Midland Rail Hub TWAO consultation response - Railfuture West Midlands branch

Executive Summary

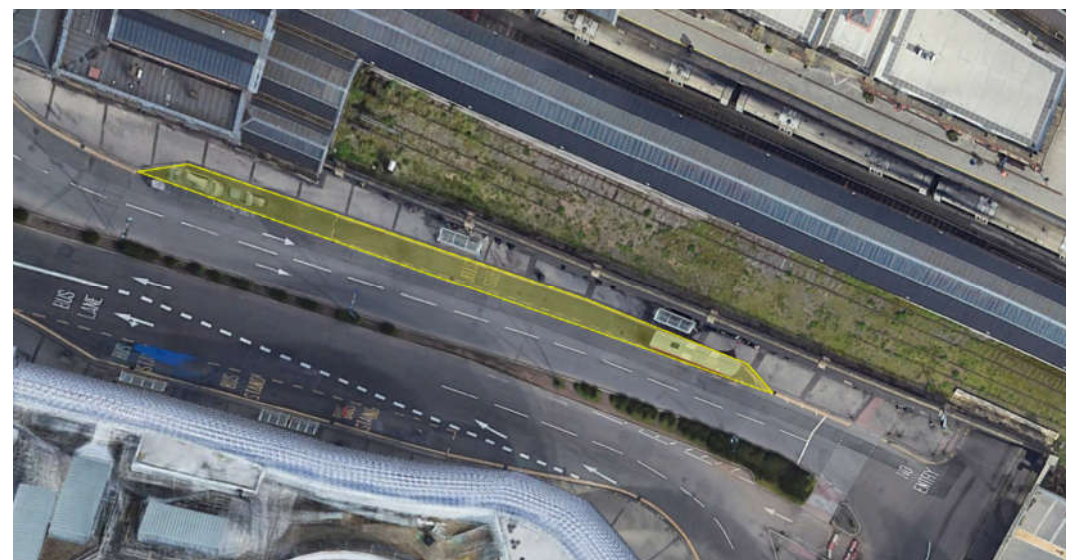
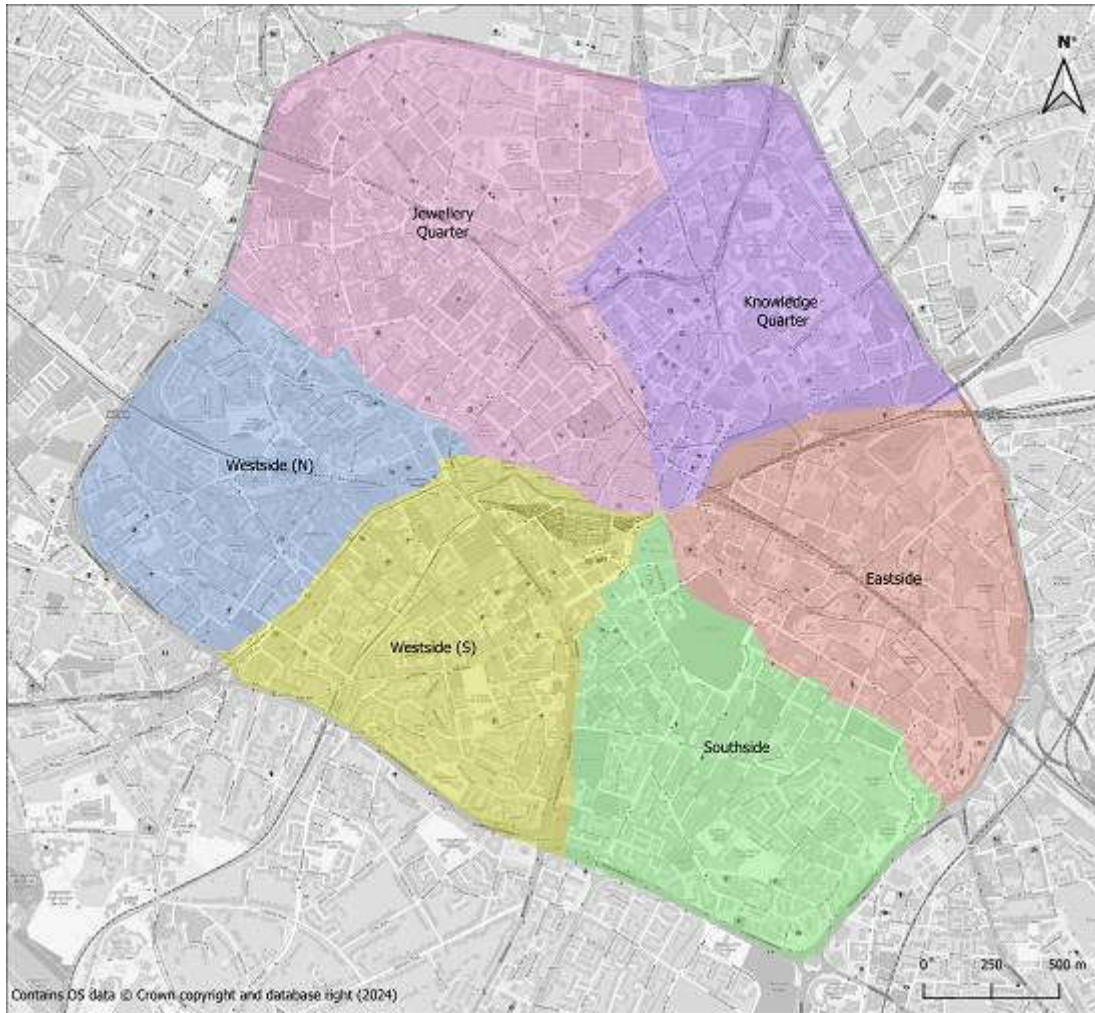
Our initial estimate indicates that the maximum usable platform length that could be created after allowing for buffers etc is 245m

Based on satellite image, there is no doubt that the viaduct is already wide enough to accommodate railway vehicles, so additional width that may be required would be limited to the platform on which passengers stand, which significantly reduces the scale of the civil engineering involved.

Whilst it is only from satellite image, it appears plausible to suggest that a platform compliant with the minimum width of 2.5 can be created within the existing viaduct, although this would narrow to a pinch point half way down the platform, before opening up to an area where a 5m deep platform can readily be accommodated. This may be acceptable if wayfinding can be used to direct primary passenger flow directly to the intermediate access to the platform via bridge etc, rather than directly from the concourse at the western end.

If a small amount of additional width is required then this can readily be accommodated.

Viaduct expansion

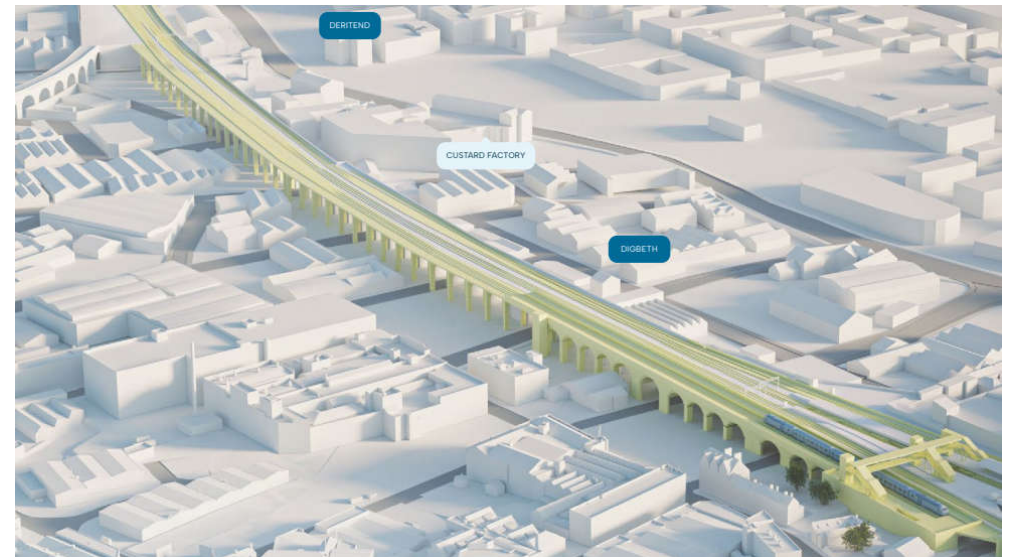
We are very strongly supportive of delivering a total of 6 running lines from the intersection with the Camp Hill line to provide 2 lines running through Moor Street P1+P2 and then through Snow Hill tunnel, plus 2 running lines north of this to new platforms at Moor Street to provide services to North / East, plus 2 running lines to the south to provide access to services to South / West.

However, historically most sections of the viaduct had between 5 and 6 running lines on it (OS 1:1250 maps), but the FAQ document mentions a figure of 15m of additional width being required.

The promoter must demonstrate why 15m of additional land is essential to deliver 1-2 additional tracks, for vehicles that are a maximum of 2820mm wide. Clearly, we are neglecting dynamic gauging and access requirements, but the local community and planning inspector will need a full explanation as to the need for land acquisition on this scale down the entire length of the viaduct.

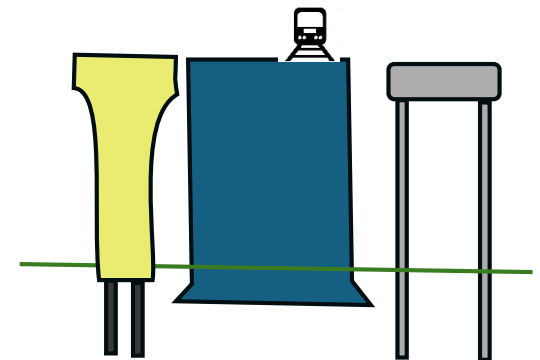
The Victorians created impressive structures, but their foundation depths were often surprisingly shallow. We note that some of the rendered images indicate two supporting pillars in a goalpost configuration (diagram right).

A single larger central support may allow the new structure to be positioned closer to the existing masonry structure without impacting the foundations of the existing viaduct or restricting access for maintenance.

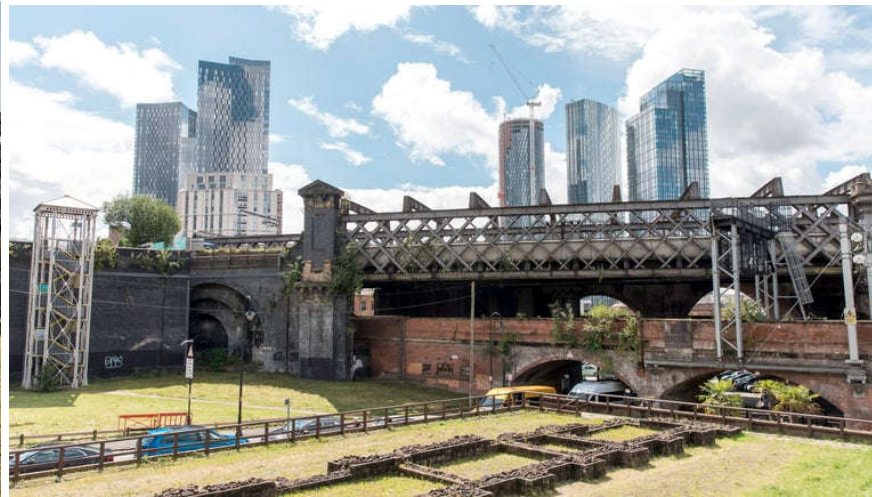
Newer simply supported steel, devoid of any architectural merit or interest whatsoever, entirely utilitarian.

Older steel truss form, providing more visual interest and an attractive curved form, but due to painted surface requiring far higher levels of maintenance, which is not being kept on top of, and hence rusting, does add to the general feeling of neglect in the area – even if it does not impact the structural integrity in the medium term,.

This viaduct section is proposed for removal.

New chords in this location do need to provide some degree of visual interest and attractiveness, rather than being completely utilitarian.

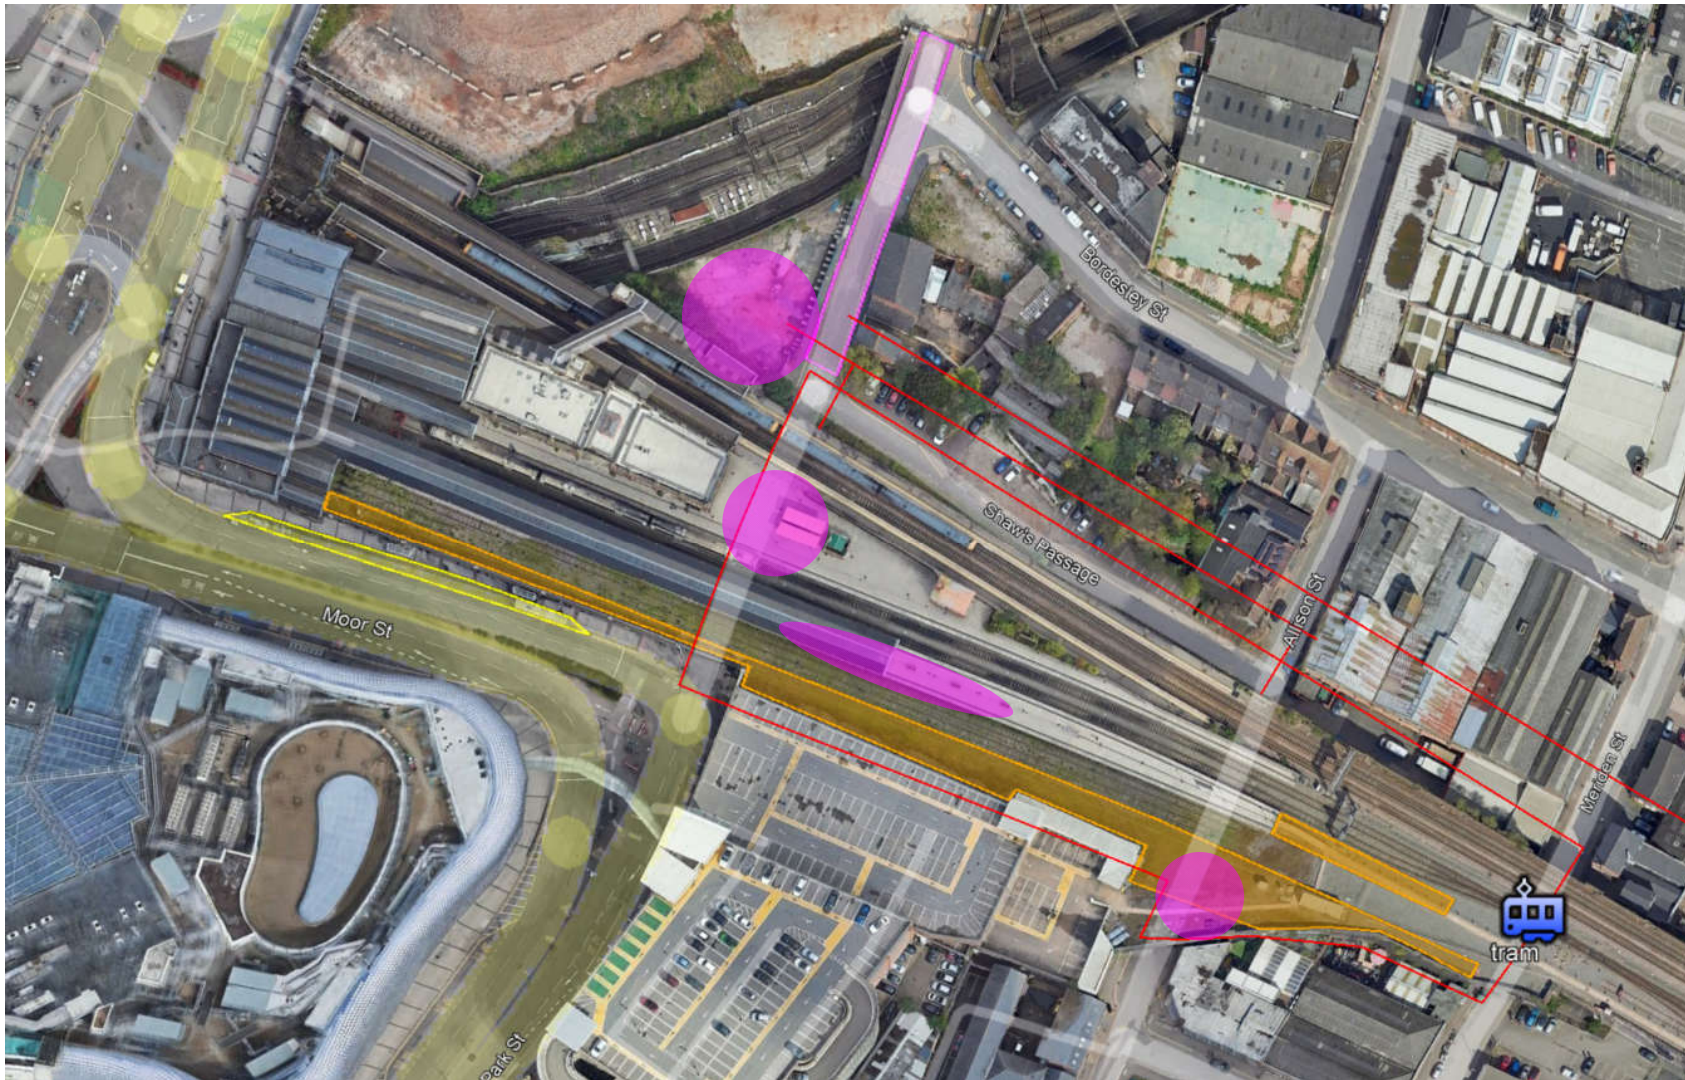
Imagine the potential of the Moor Street undercroft, the area outlined in red. This has a gross area of 1 hectare.

Park Street under the viaduct is stopped up and becomes part of the undercroft space, but still allows pedestrians to flow through.

The section of Park Street to the north (pink) becomes pedestrianised + access only, providing broad flowing access through to HS2 Curzon Street.

Alison Street under the viaduct is stopped up and becomes part of the undercroft space.

This allows the undercroft space to extend to adjacent Meriden Street. Re-locating the tram halt 100m south to the position shown would allow direct access from the undercroft space to the tram halt platforms.

Meriden Street under the viaduct should be made tram only to encourage cars to use another parallel street, to provide a calmer / active travel orientated street in the station surroundings.

Appendix: platform notes

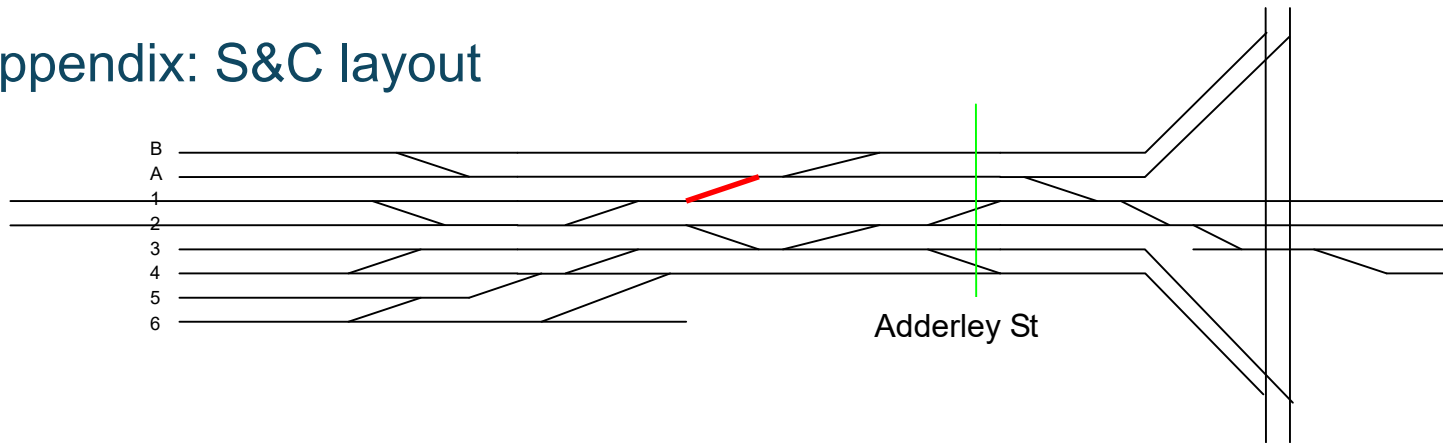
A+B+1: good space to create wide stairs, but from far end of A back to tram is long 500m walk – requires intermediate small stairs + lift

2+3: good space to create wide straight stairs- good flow from existing concourse (near historic location of wagon lift, hole may exist ?)

4+5: Narrow, likely require two narrow staircases so flow can be separated into one-way up and down passenger flow.

6: Good space for stairs and lifts
